<b>Subject:</b> <b>REAR DIFFERENTIAL VENT CAP FLUID LEAK IN COLD AMBIENT TEMPERATURES</b>	<b>Bulletin No:</b> 03-003/13
	<b>Last Issued:</b> 10/31/2013

2011 Tribute equipped with AWD

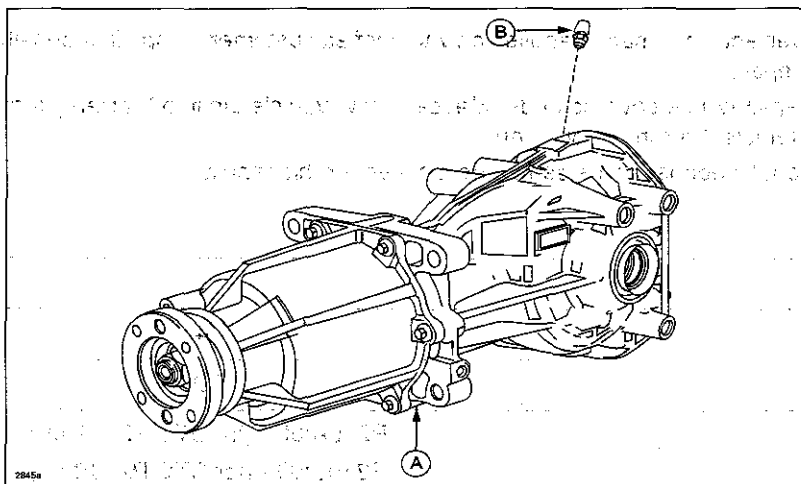
Some vehicles may exhibit an occasional fluid leak coming from the rear differential vent cap in temperatures below 32 degrees Fahrenheit (0 degrees Celsius) under certain conditions.

1. Inspect the rear drive unit (A) for oil leaking from the vent cap (B) located on the rear cover.

3. Remove and discard the vent from the rear drive unit cover.
4. Install new vent.
5. Clean off any remaining residue.
6. Verify repair.

Part Number	Description	Qty.
ZZC1-17-530	Vent Valve Assembly	1
